Appl. No. 10/645,212
Amdt. dated October 22, 2004
Reply to Office Action of May 7, 2004

Amendments to the Drawings:

Figure 4

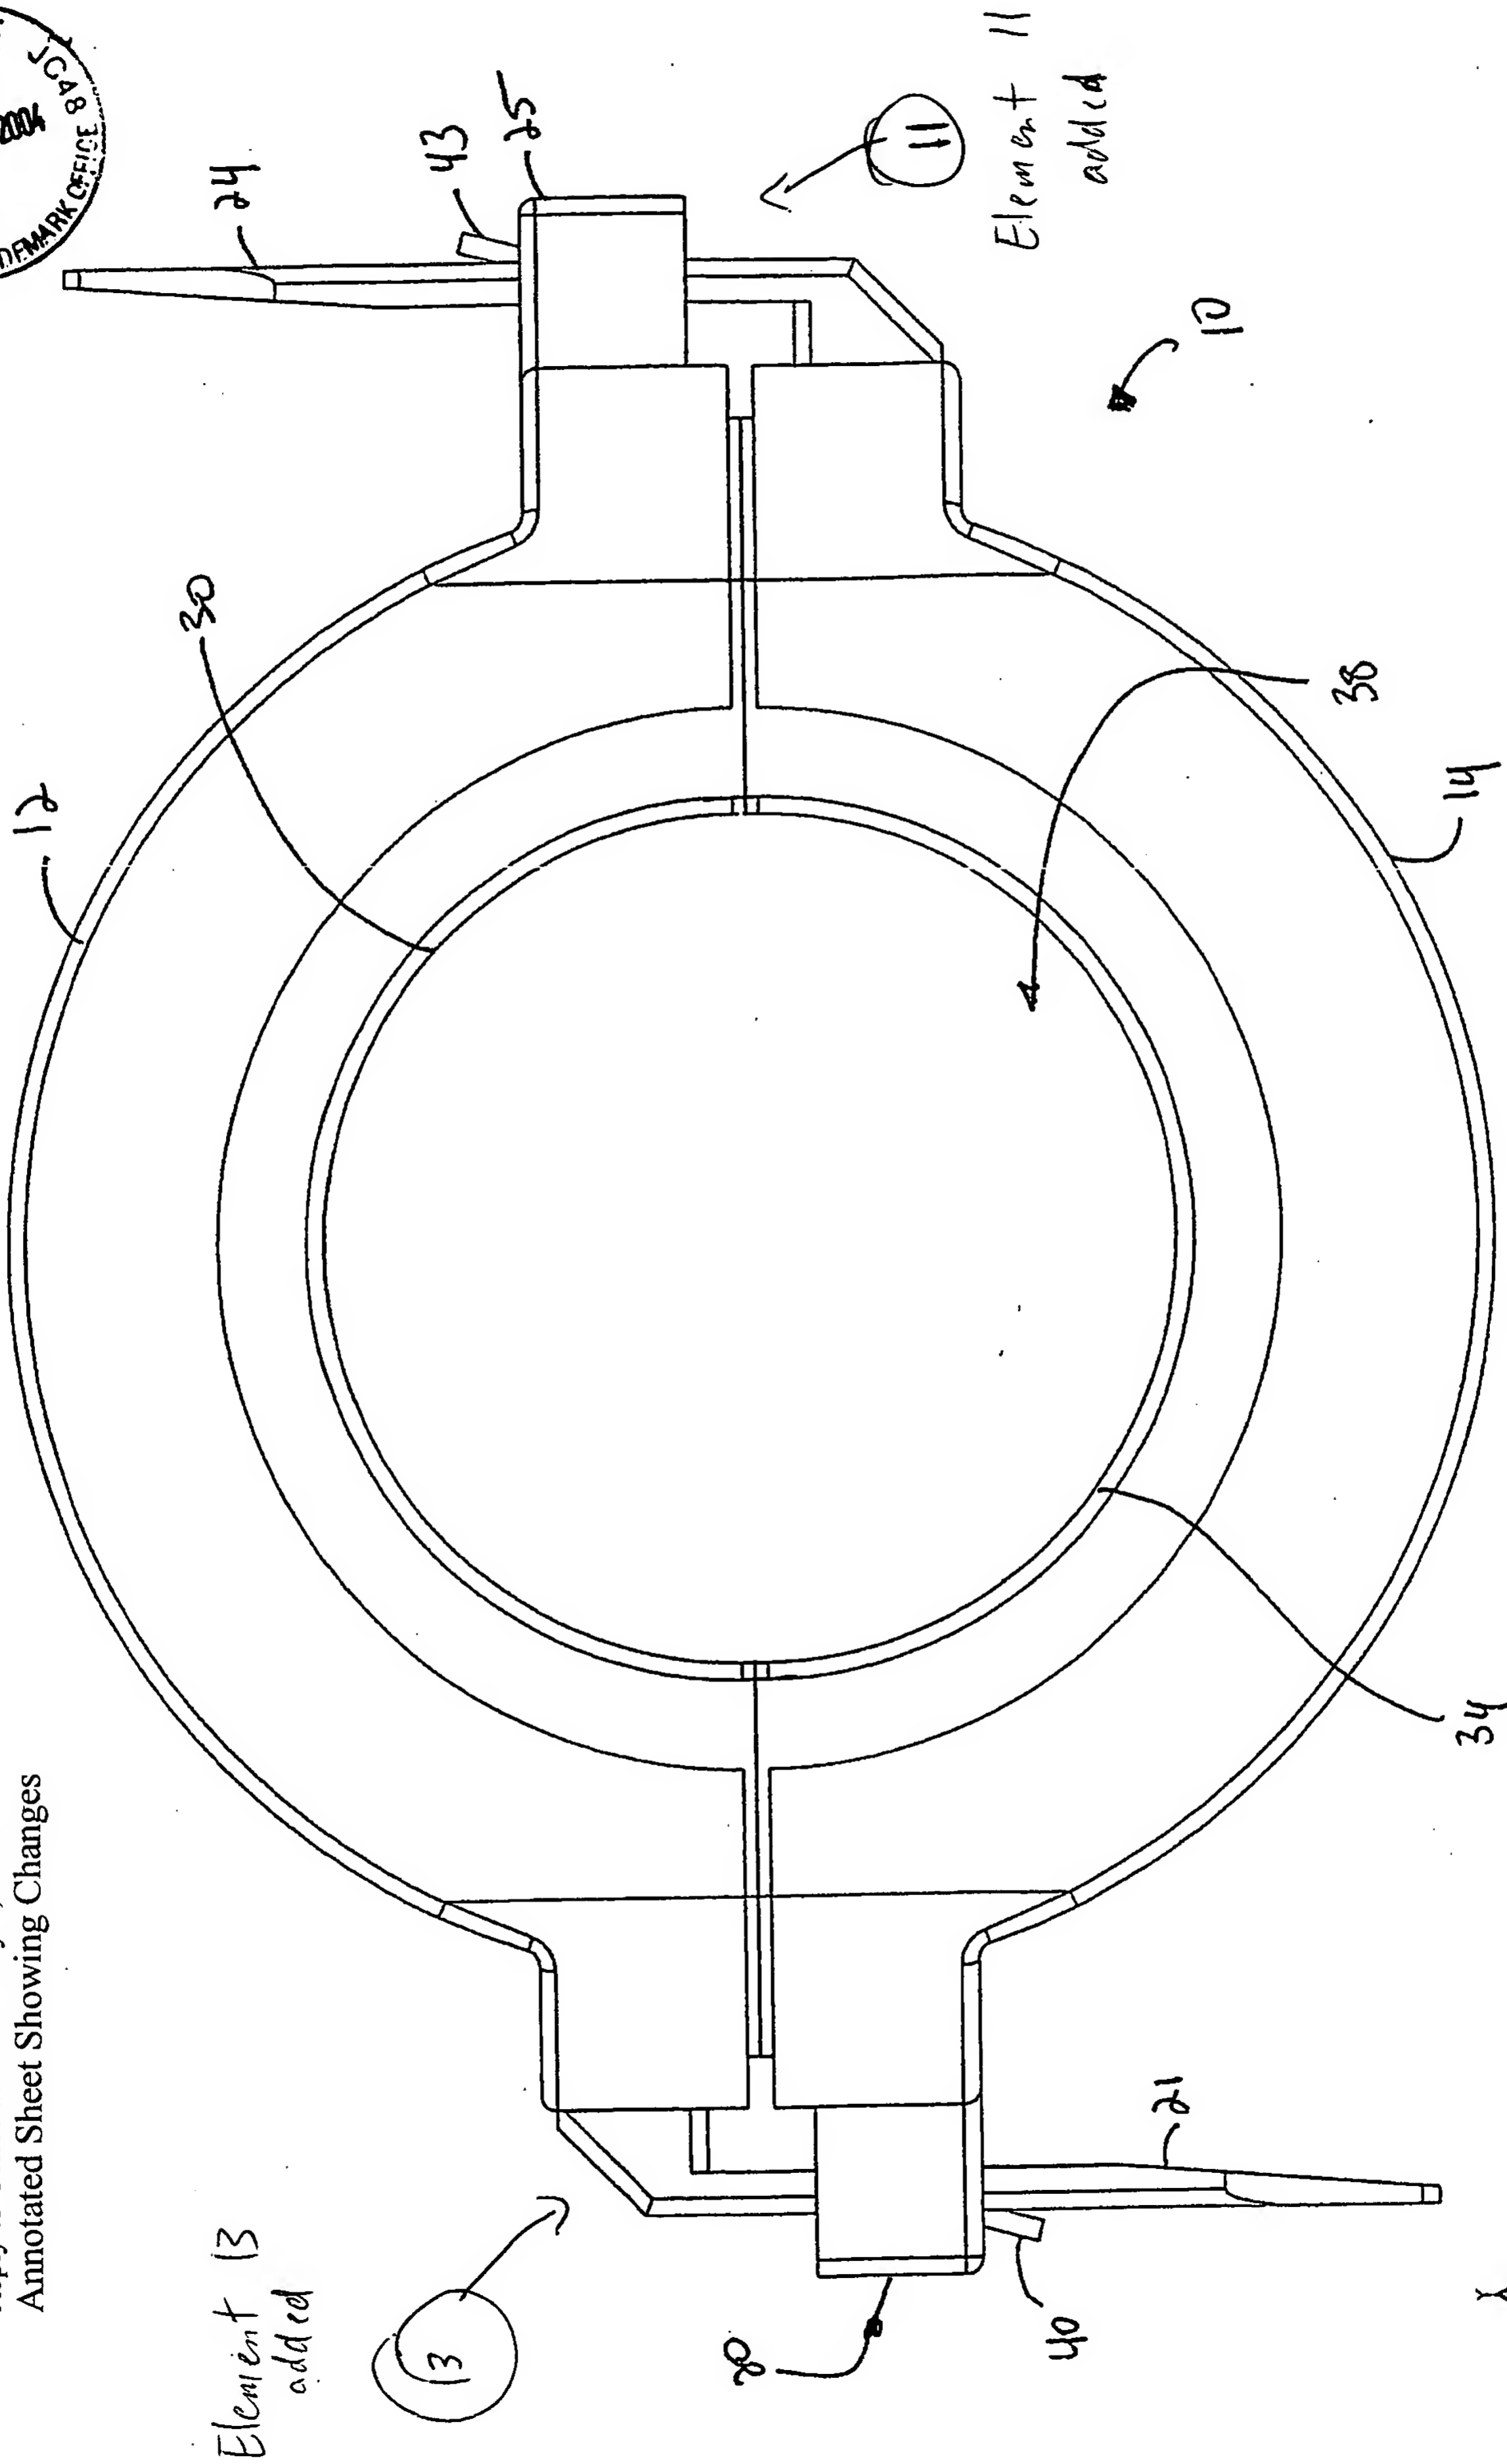
The attached sheets of drawings include changes to Figures 2 and 4. These sheets, which include Figures 2 and 4, replace the original sheets including Figures 2 and 4. In Figure 2, previously omitted element 11 has been added. In Figure 4, previously omitted elements 11 and 13 have been added.

Element 13
added

Element 11
added
